# **PRELIMINARY DRAINAGE PLAN PUD/SP 22-001**

## **HILLSIDE AT LORSON RANCH**

**JANUARY, 2022  
REVISED APRIL, 2022**

POND G  
WQ POND  
OUTLET STRUCTURE DETAILS

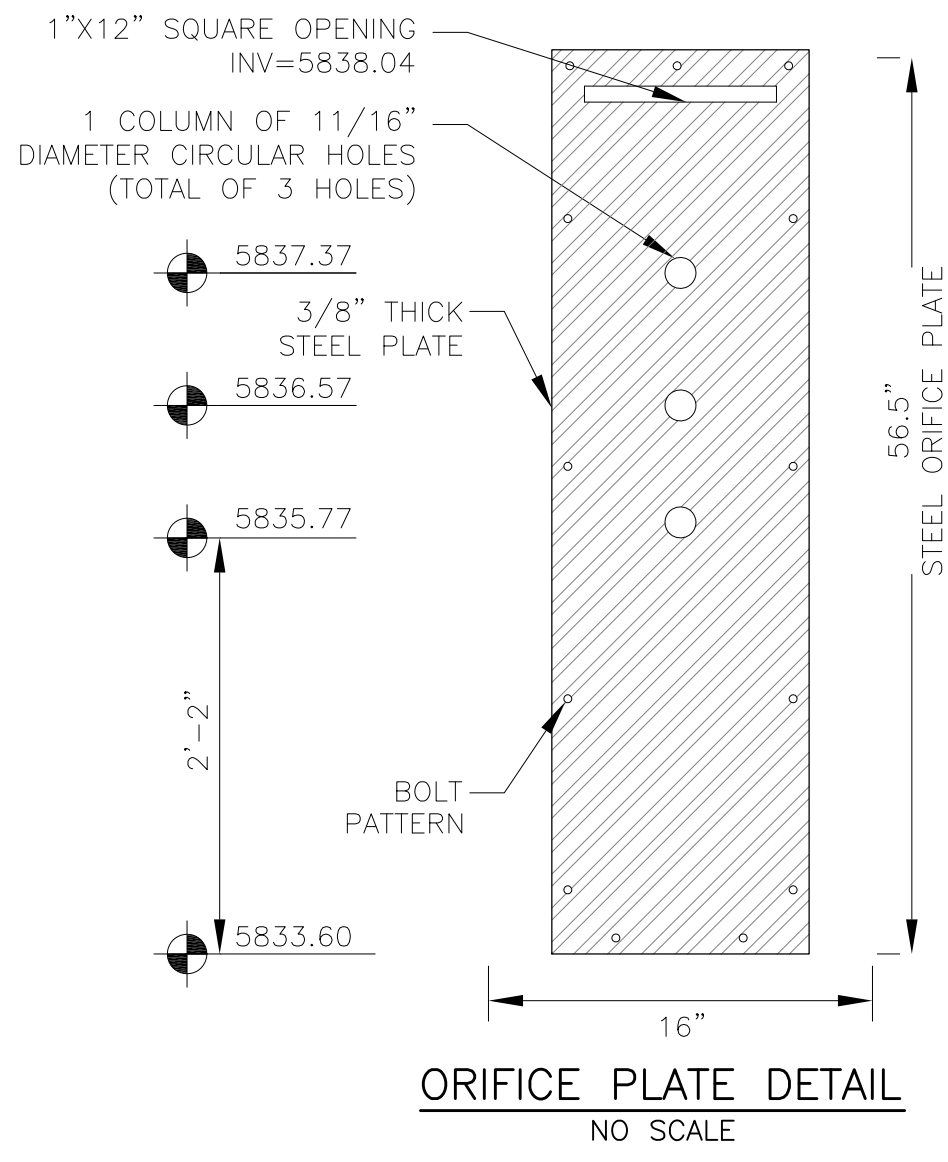
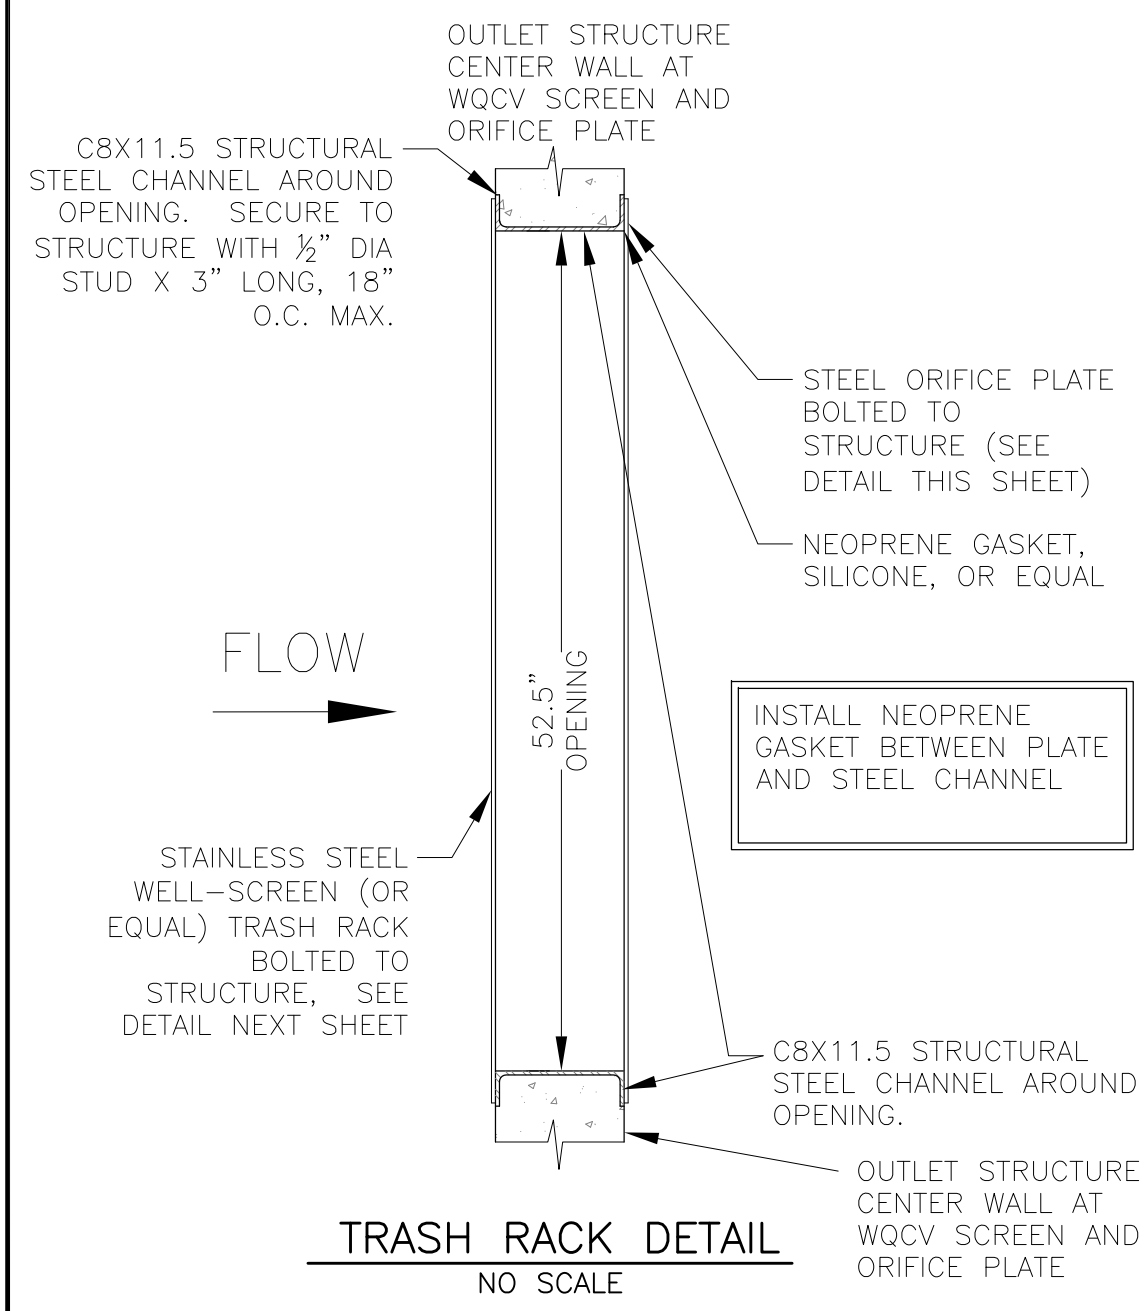
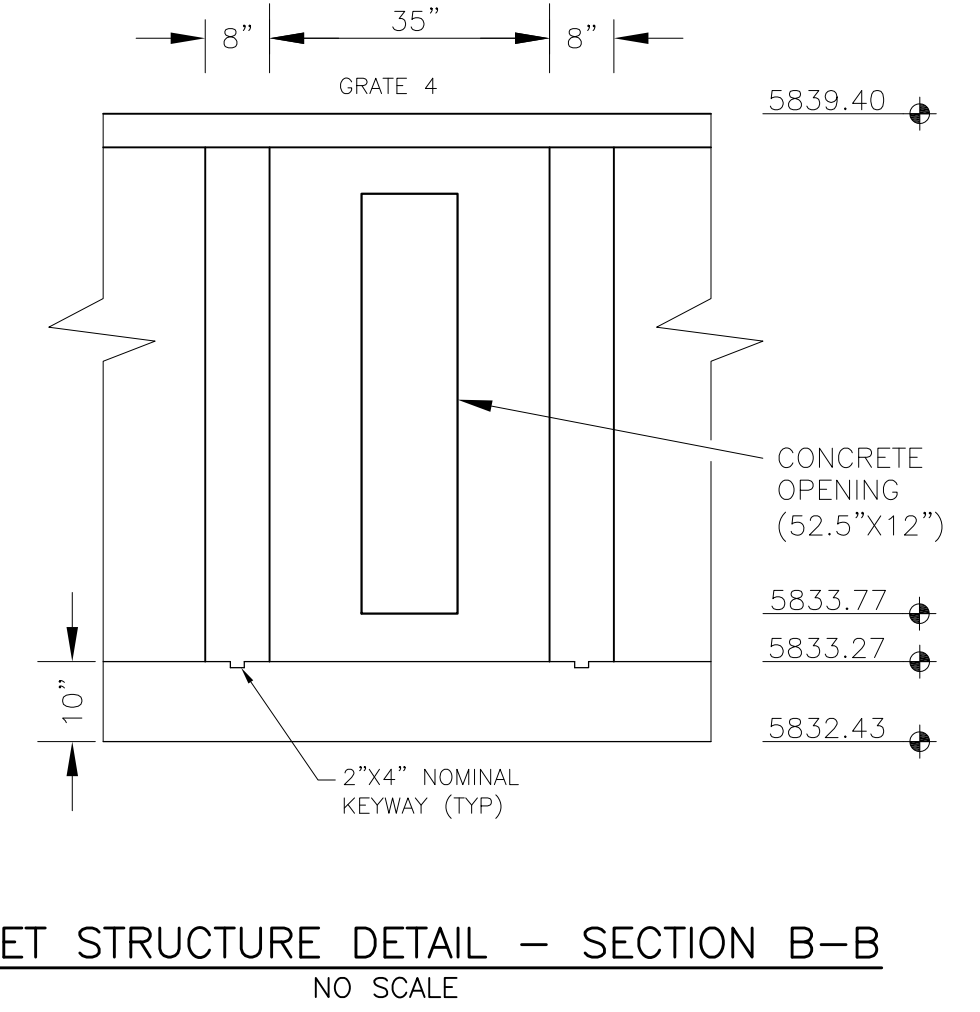
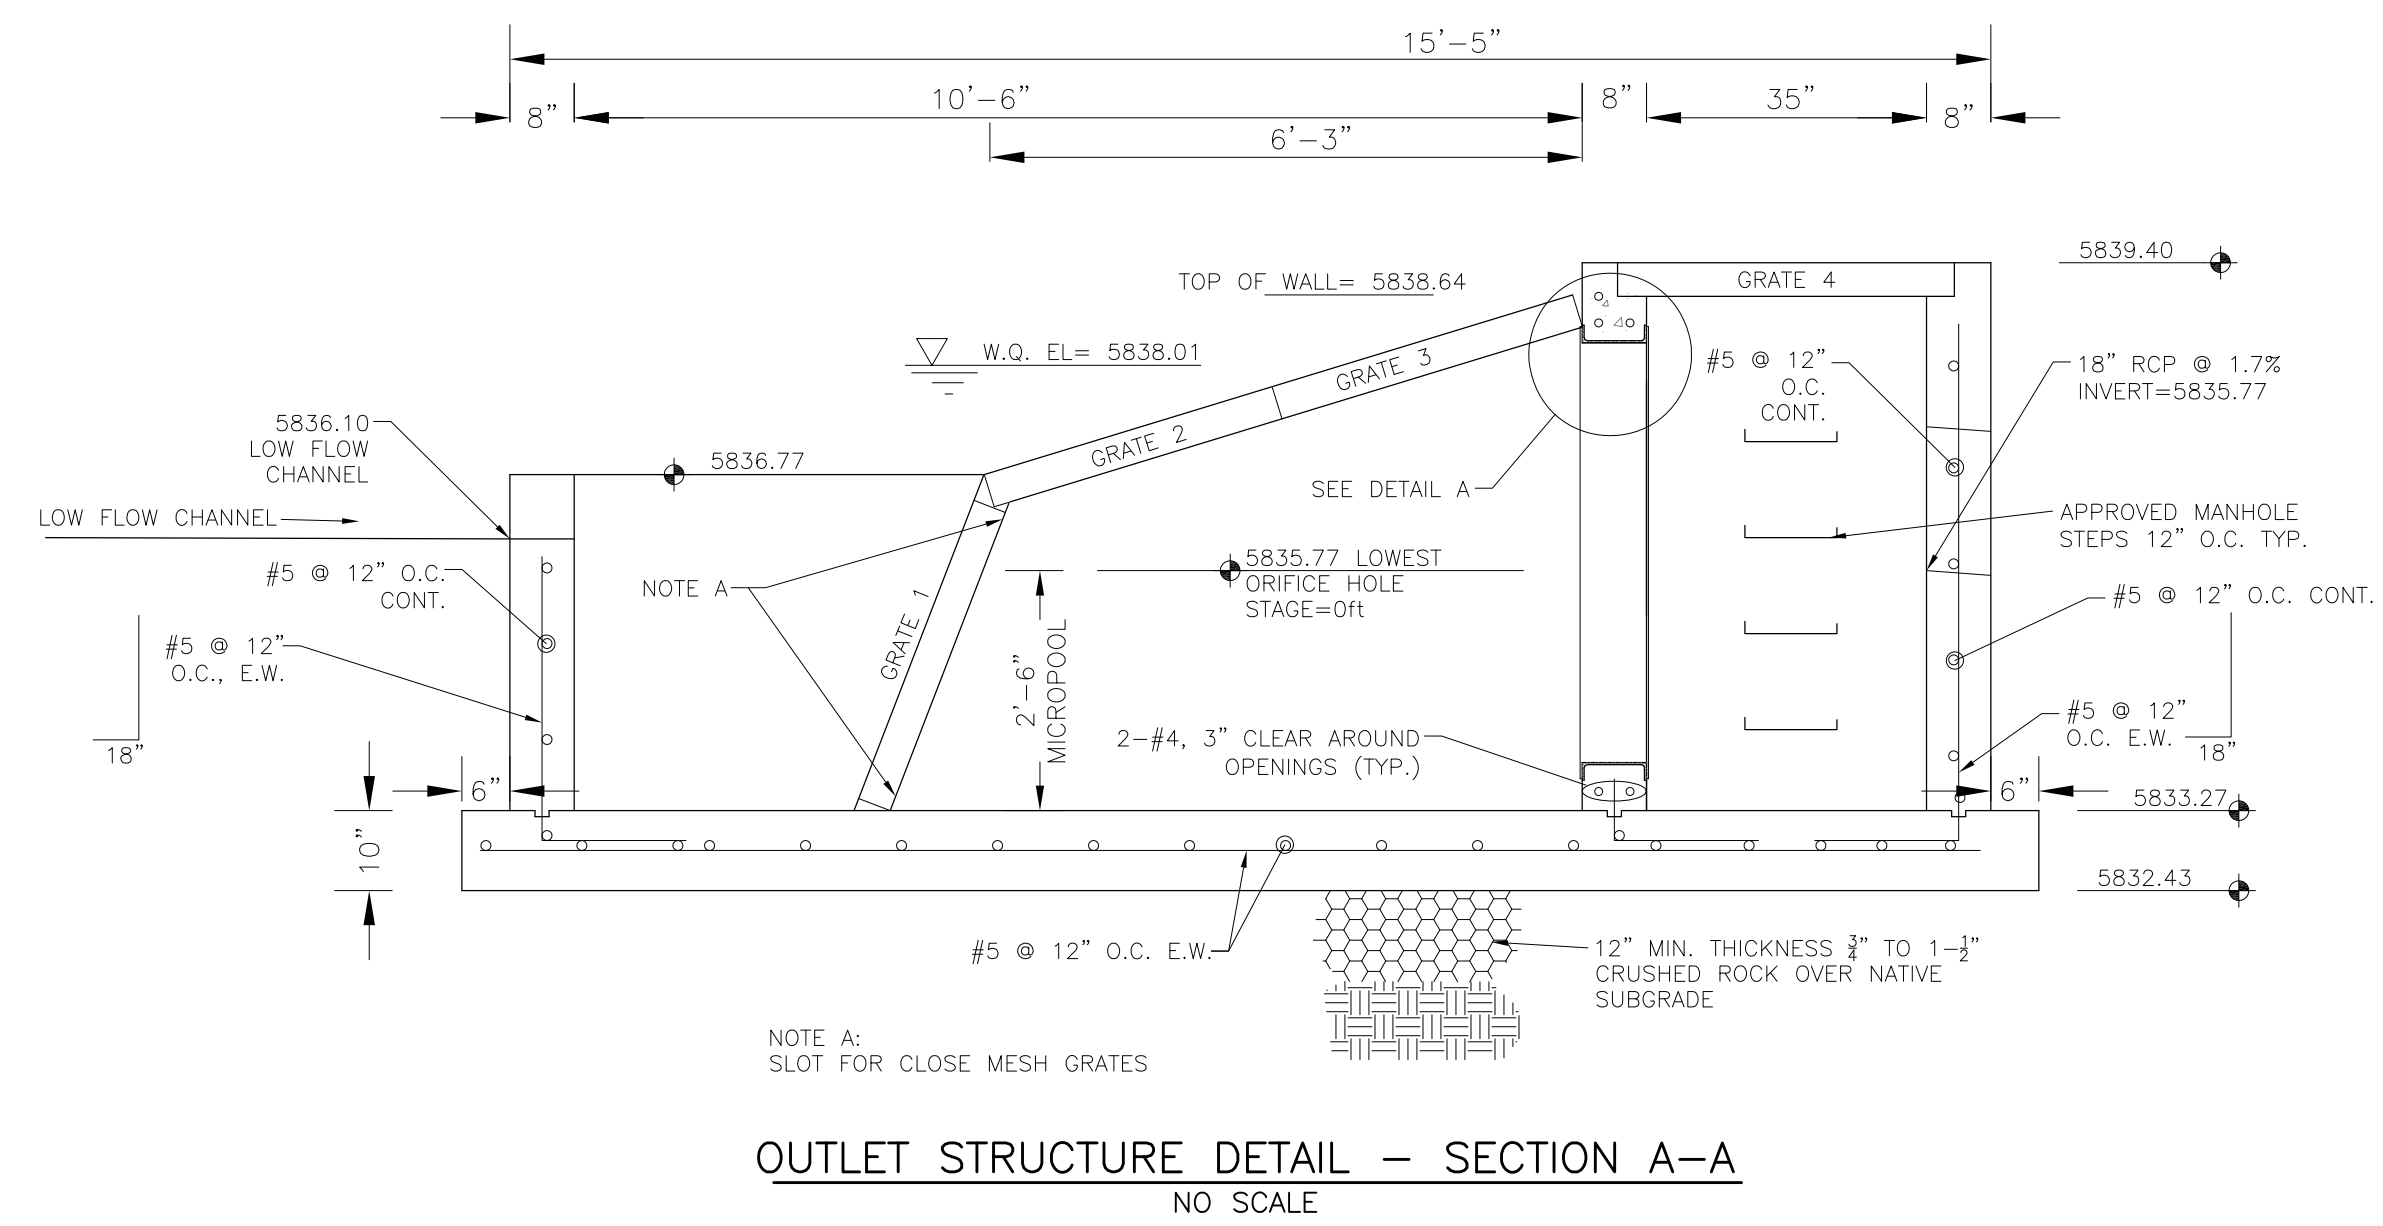
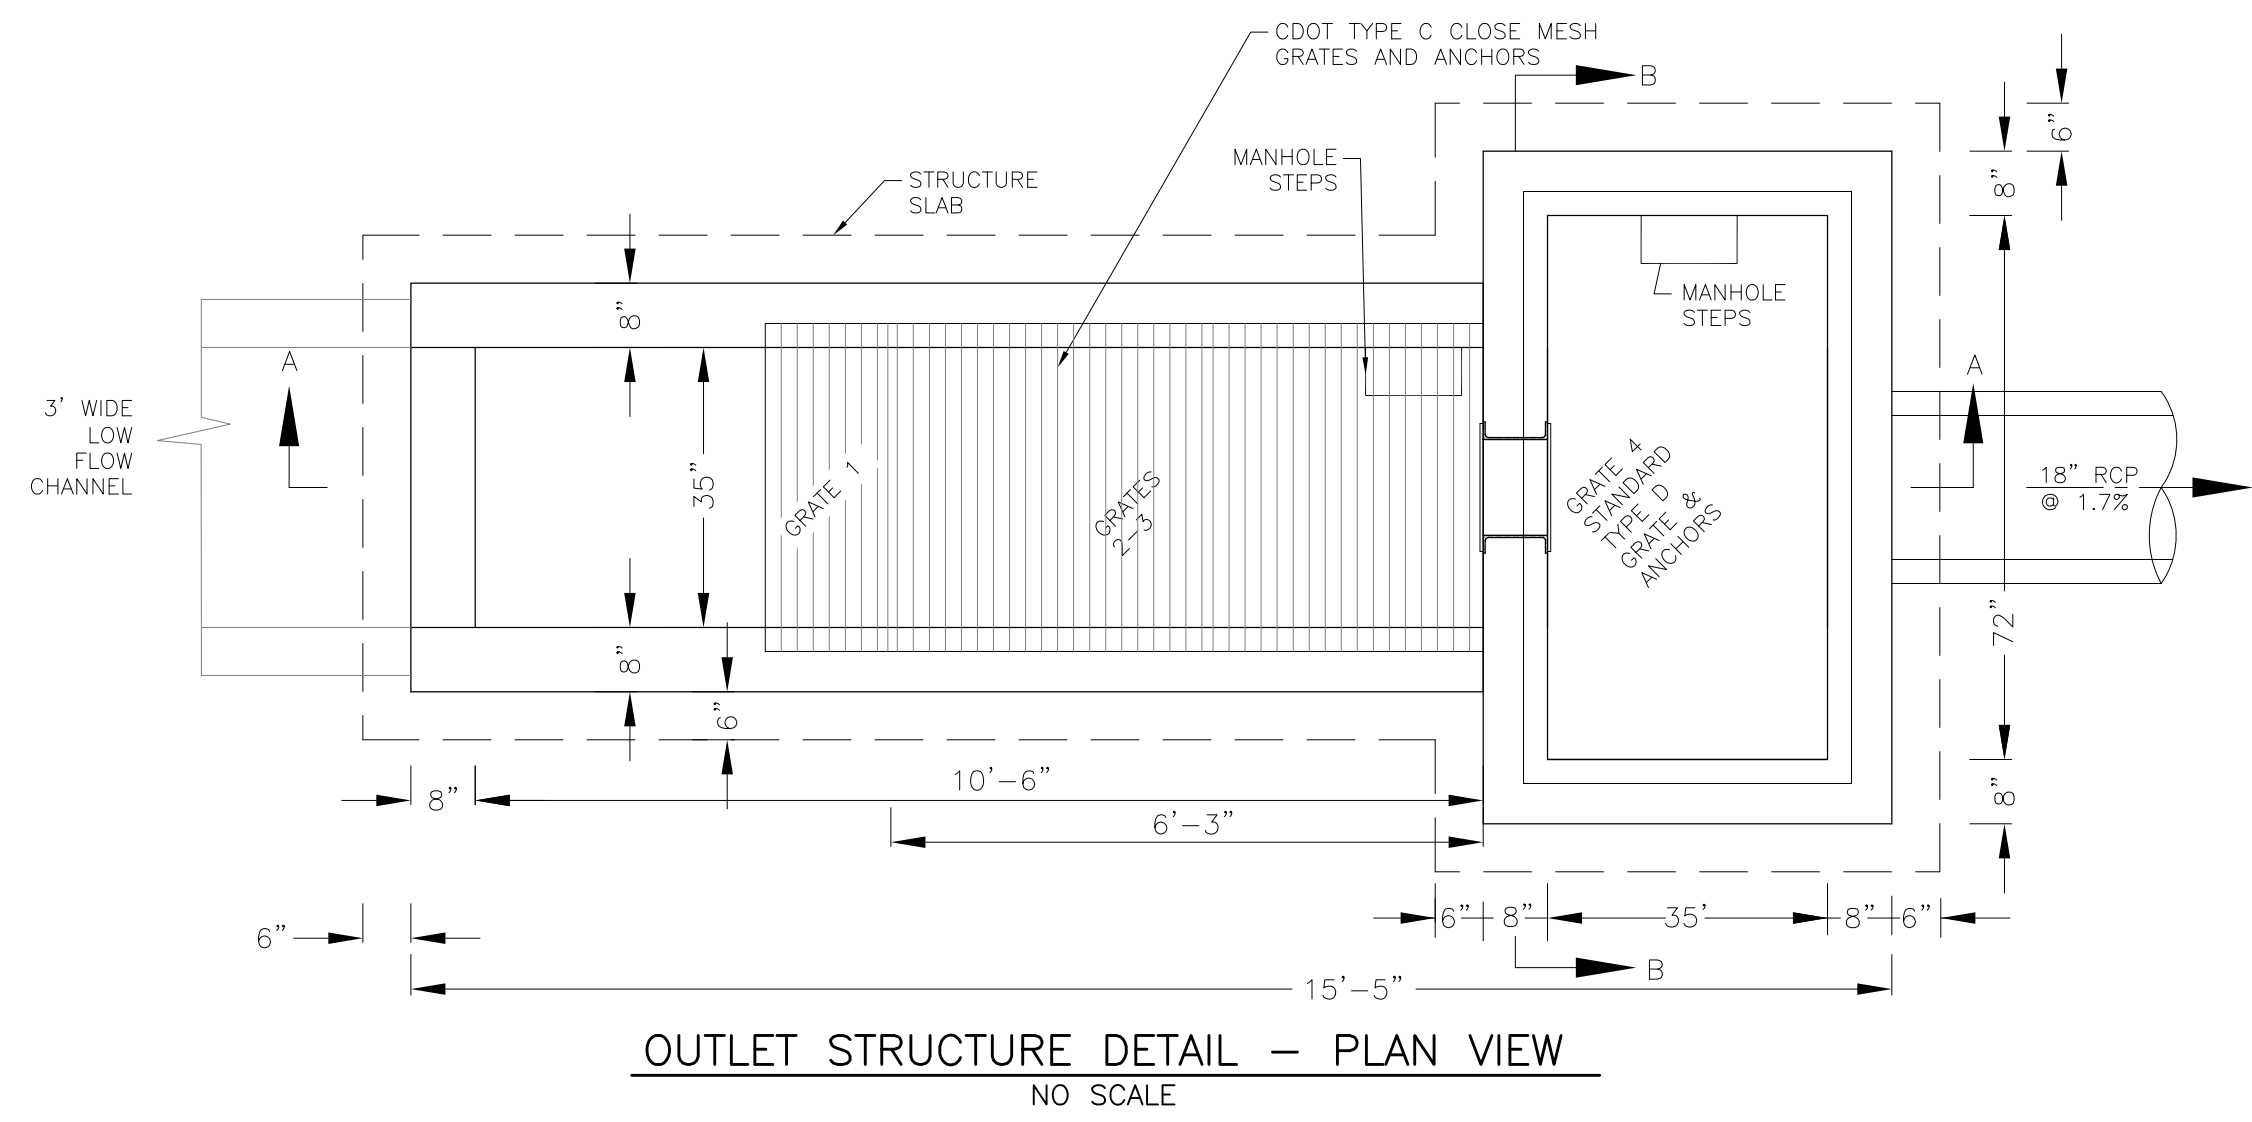
Use updated drawings
